RE: PZ# 25-12000026 CPTED Waiver for Rising Tide Car wash (2901 W ATLANTIC
BOULEVARD POMPANO BEACH FL 33069, folio 484233450010)

The above-referenced Site Plan application has been reviewed by the Development Review Committee and discussed at the October 15th, 2025 DRC Meeting. Comments are being addressed and resolved with each discipline reviewer, though 3 outstanding comments are related to a necessary zoning code modification/waiver that would otherwise result in a development conflict with the City's CPTED guidelines as well as adjacent property conditions. We would like to take the opportunity to justify the need for Director modification/waiver in accordance with code sections 155.4219.A.1.b [Standards Applicable to Motor Vehicle Sales, Service, and Storage Uses] and 155.5203.F.2.e [Perimeter Buffers; Applicability].

CPTED Style fence example is shown on the following page.

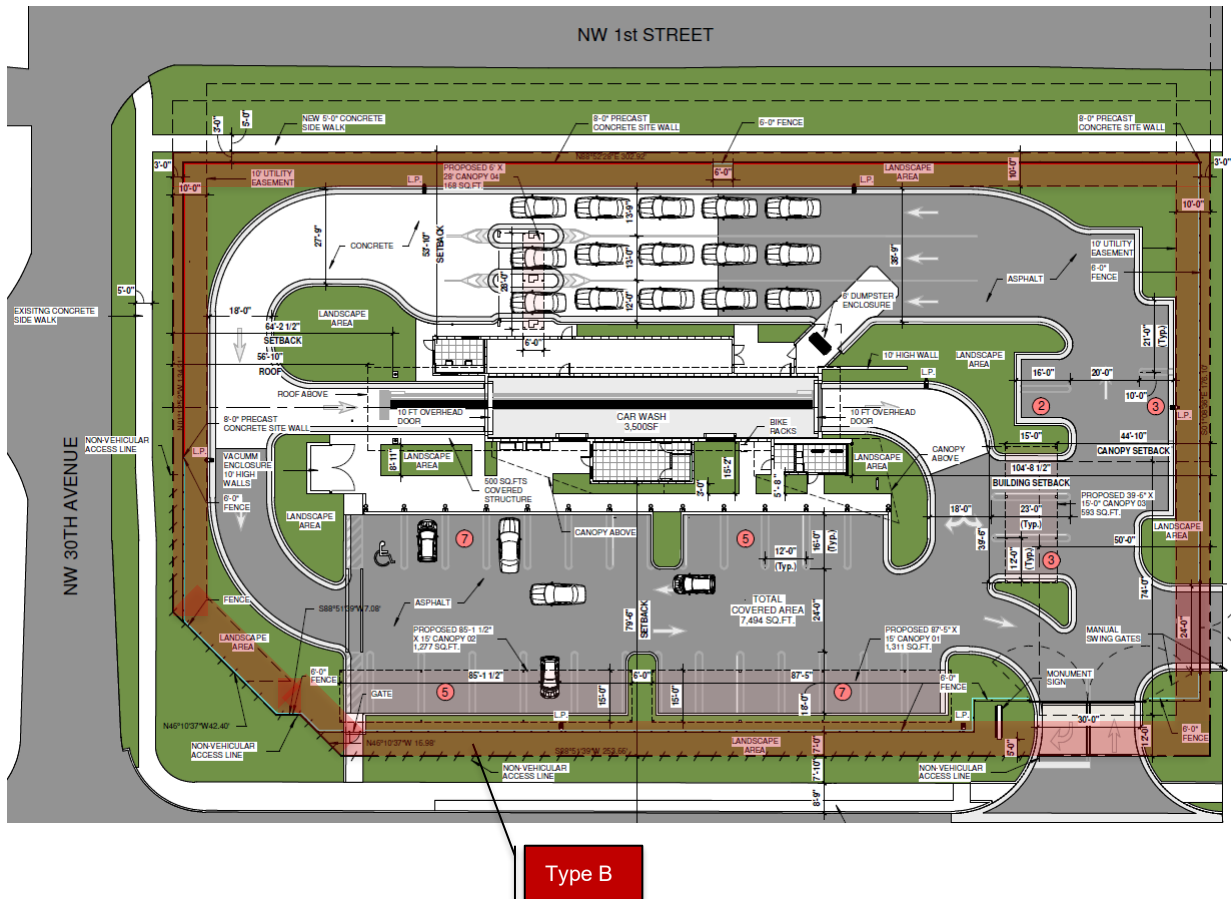
As shown below, the property is surrounded by 3 streets to the north, west, and south. Across the north side is a residential neighborhood that would benefit from a privacy wall along that perimeter. As a Type B Buffer is required per code section 155.4219.A.1.b for all perimeters, we request all continuous hedging required within the Type B Buffer be eliminated where the proposed CPTED fence is shown. For a portion of the west, all of the south, and all of the east perimeters, we propose the buffer barrier to be a CPTED-style high-visibility fence, in accordance with conversations had with BSO Deputy Anthony Russo.
